Reference: A/18/8/PL for Application for Variation of Condition 2 imposed under A/173/16/PL to read "the development to be carried out in accordance with the following approved plans ADC962/04 REVA, ADC962/13 & ADC962/14 relating to revised position of rooflights on east, north & south elevations. This application affects the Character & Appearance of the Angmering Conservation Area at Land Rear of 1 To 6 The Cottrells Angmering

Location: Land Rear of 1 to 6 The Cottrells, Angmering

Inaccuracies and Inconsistency on Plans

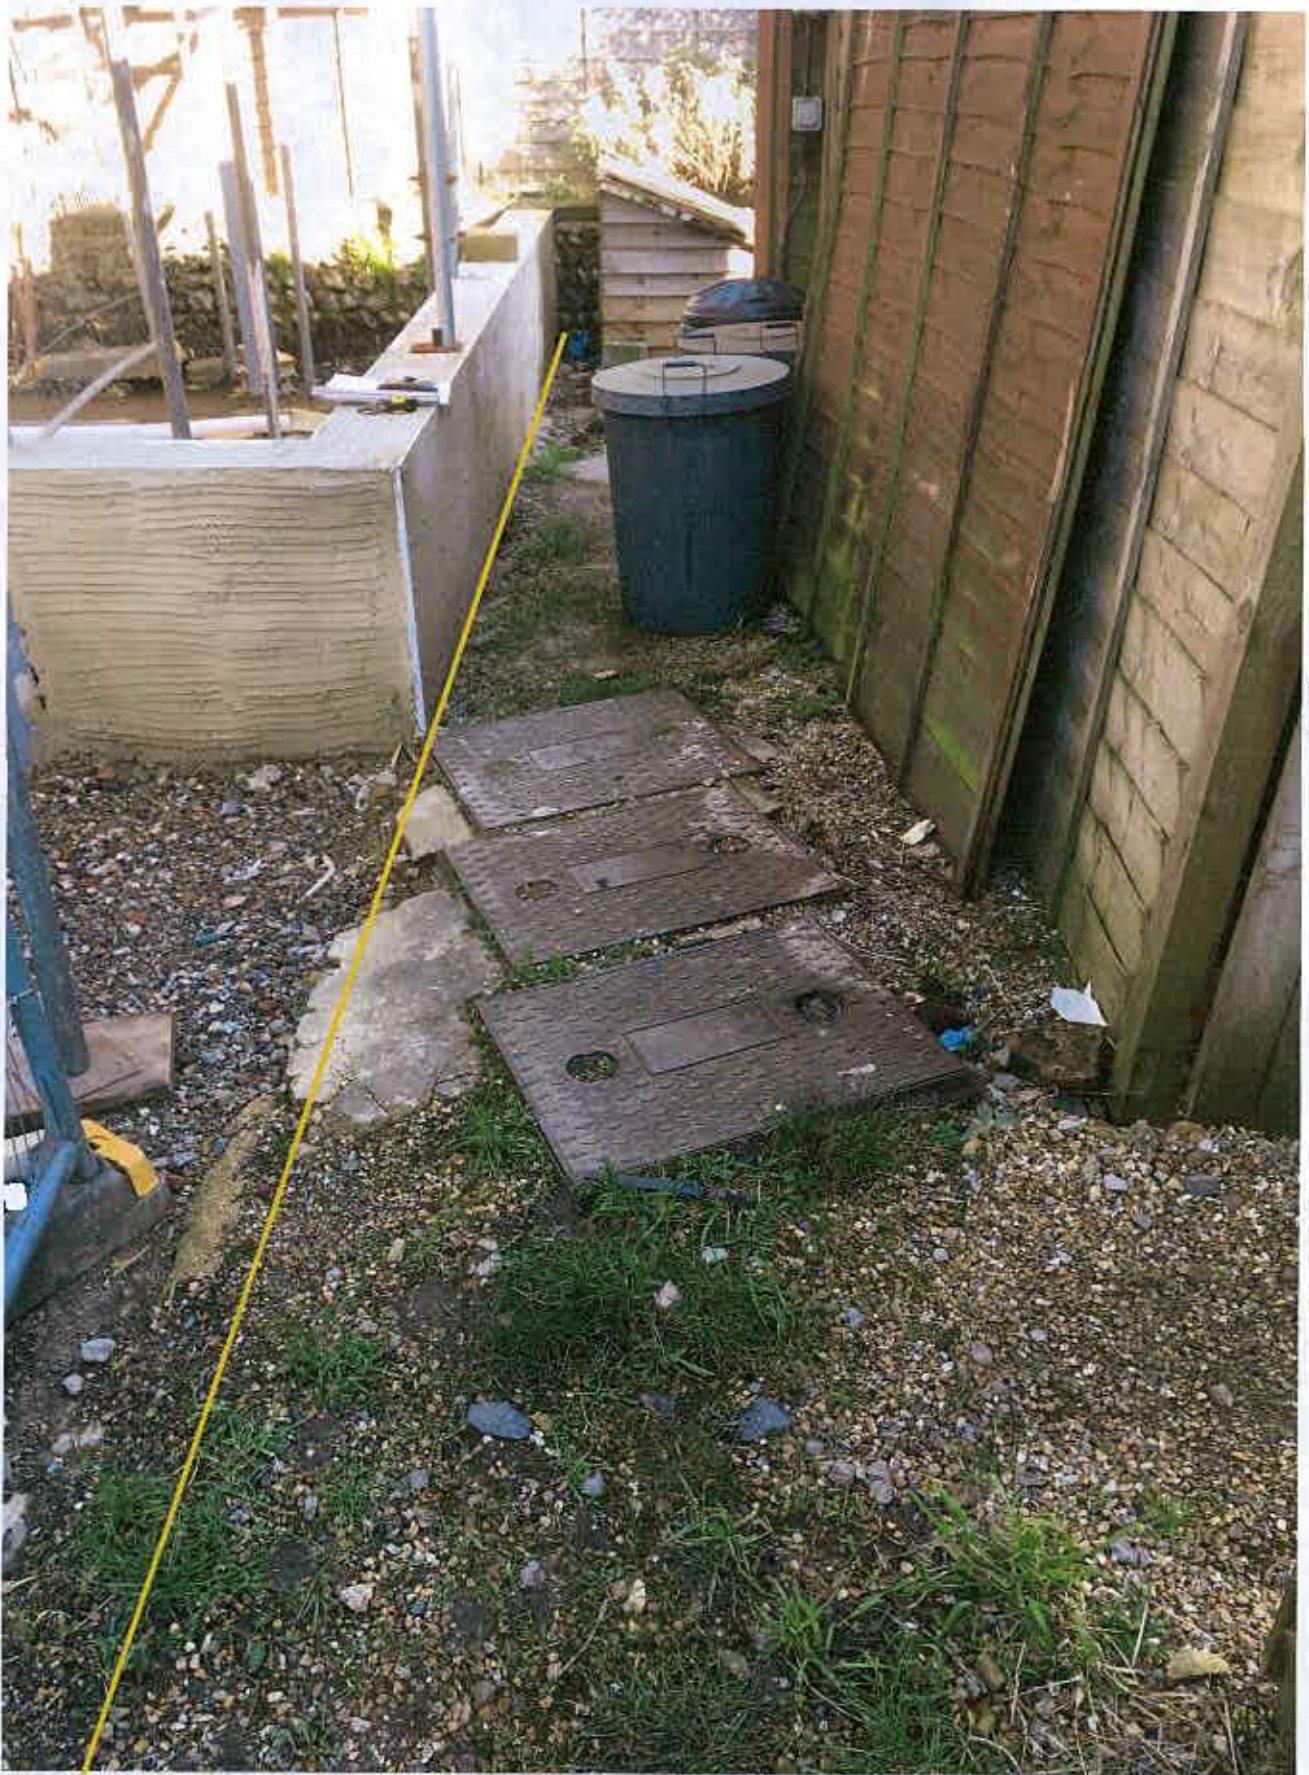
The below photographs taken from The Cottrells road, the shared alley way at the rear of No.s 1-5 of The Cottrells and from ground level and first floor level on my property. They show the towering and domineering nature of the building under construction.

Although I am not an architect or surveyor, I do not believe that the currently constructed roof ridge and the current west elevation window position would allow for a hip to be constructed without the roof and guttering overhanging my property. To achieve the hip end I believe the roof ridge needs to be reduced.

The below photographs also demonstrate the domineering nature of the whole development. It is shoe horned into a small site, I have to ask how is it that a two bedroomed apartment has the appearance of being larger than the neighbouring five two / three bedroomed houses? This has an adverse impact on the neighbouring properties and blocks light from some of the properties including those stretching beyond the new development's boundaries.

I request that the roof is taken back to the hip end the original approved application (A/173/16/PL) and the positioning of the building to be considered so that there is no overhang over the site's boundaries and all future maintenance can be achieved from within the site itself.
